Access Compliance Report Public Rights-of-Way (Curb Ramps)

Main Street: CASTLEGATE_LN Cross Street: CASTLEGATE_LN Location: W

ADA ID: RPRK211011111230 Ramp Type: Type 1 - Perpendicular Diagonal Initial Pass/Fail: Fail Overall Compliance: No Severity Score: 32

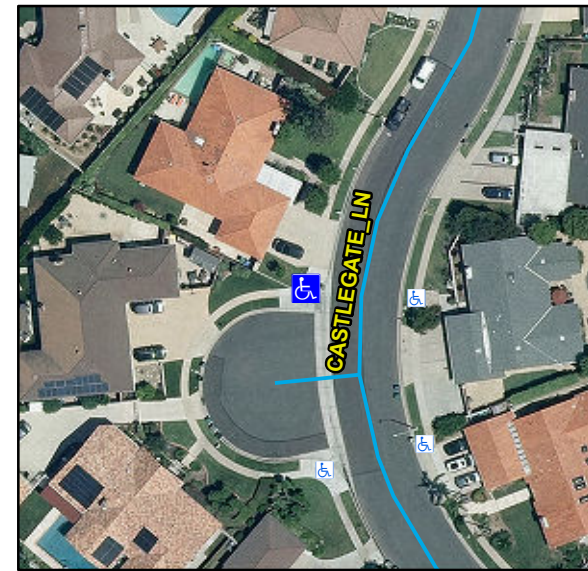
R304.2.2, R304.5.3, STD 1115

Remove & Replace Curb Ramp With Two New Directional Ramps or Equivalent.
